RPA STAFF RECOMMENDATION

Subdivision Case Number:	2015-069	PC Meeting Date: 12-14-15
Subdivision Name:	Frances Jean Avans Subdivision Lots 1 thru 3	
Applicant Request:	Preliminary/Final Plat	
Property Location:	1325, 1327, and 1329 Thatcher Road	
Property Owner:	Michelle Avans Kidwell	
Applicant:	Reid Surveying	
Total Acreage:	1.13 Acres	
Proposed Density:	2.65 dwelling units per acre	
Tax Map Number:	058I-A-018	
Zoning:	A-1 Agricultural District and R-5 Residential District	
Staff Recommendation:	APPROVE as a preliminary/final plat

FINAL PLAT
FRANCES JEAN AVANS
SUBDIVISION

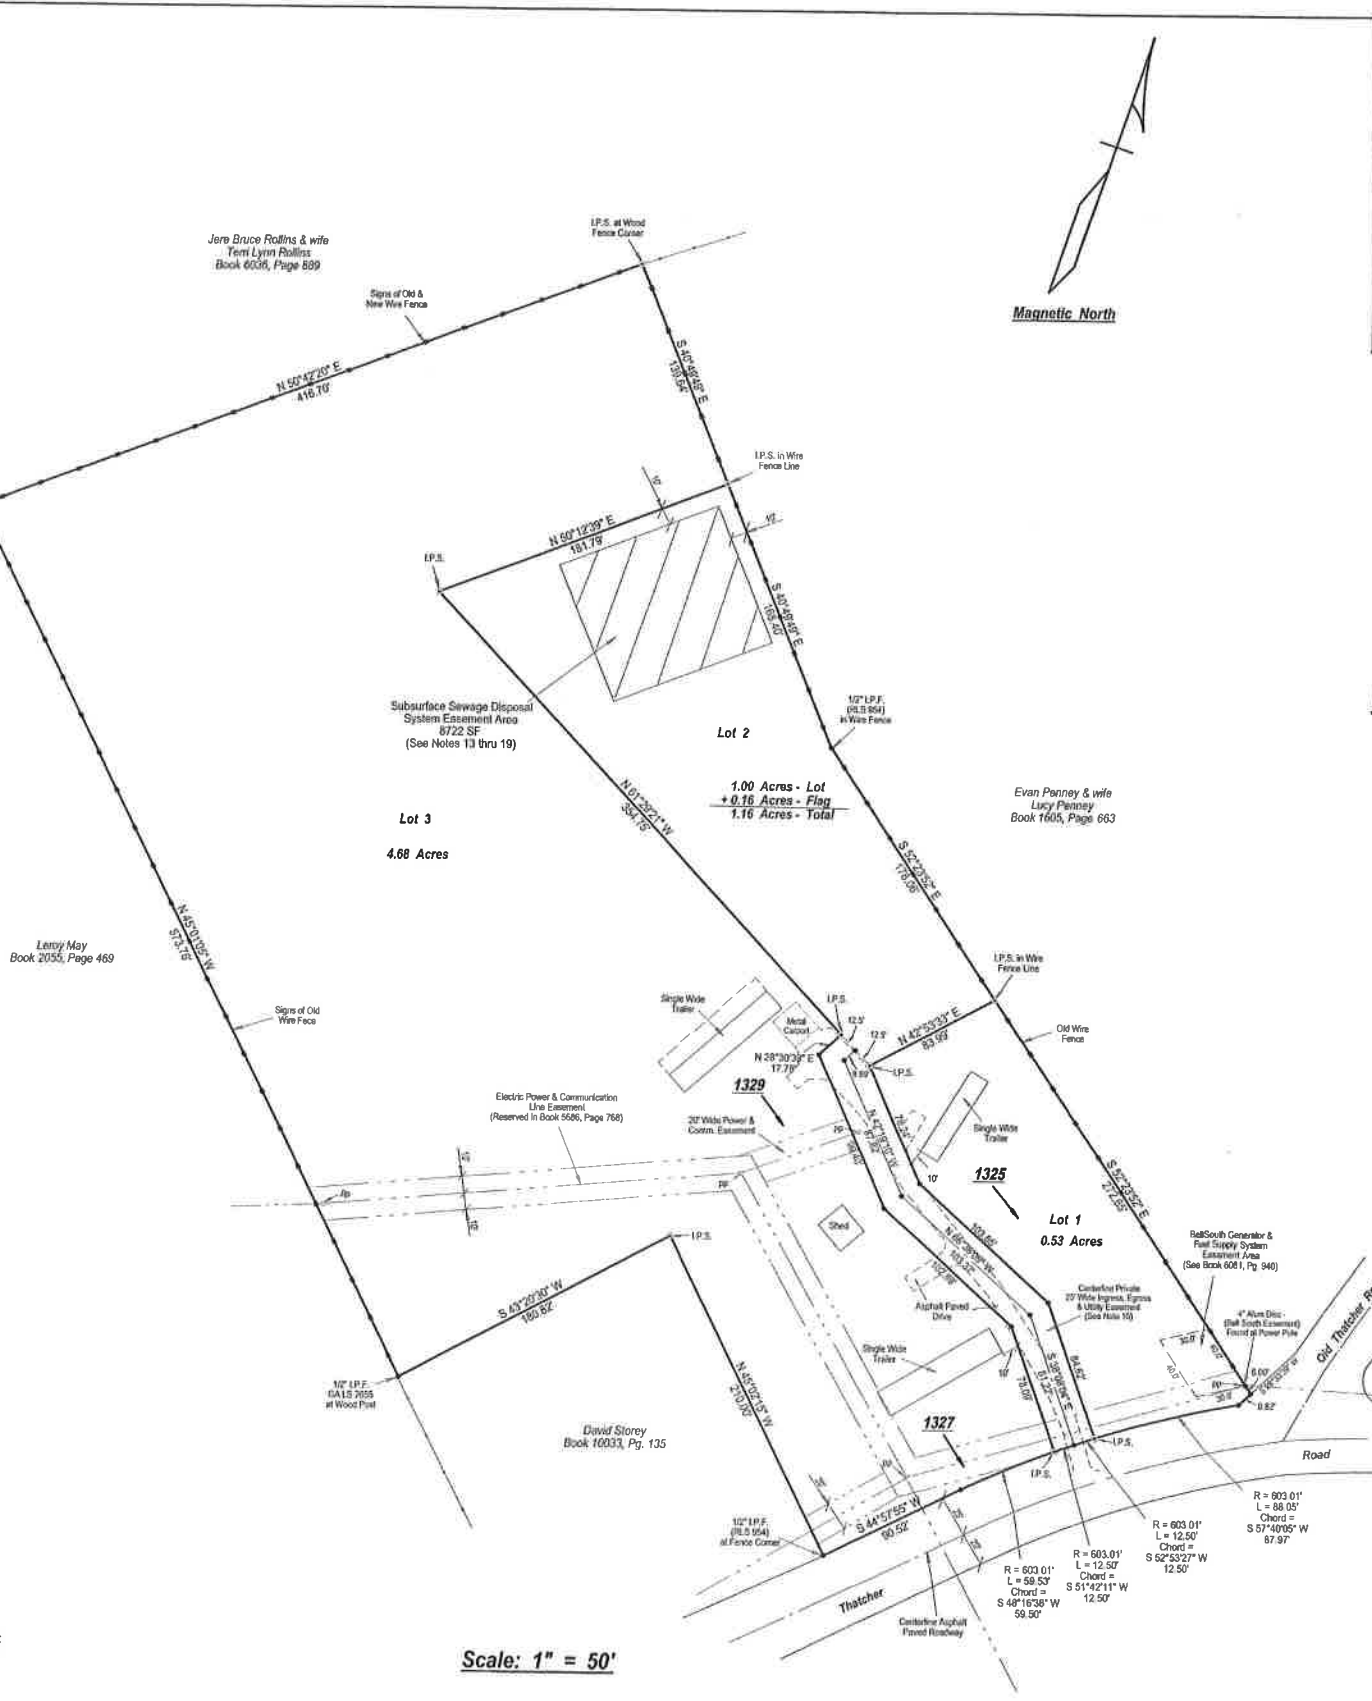
1. Submit geo-referenced CAD file to Hamilton County GIS prior to signing of the final plat.

1. Submit Geo-referenced CAD file used to create the subdivision plat to Hamilton County GIS prior to the signing of the final plat.
2. Questions concerning Hamilton County GIS comments and notes please contact GIS at (423) 209-7760.
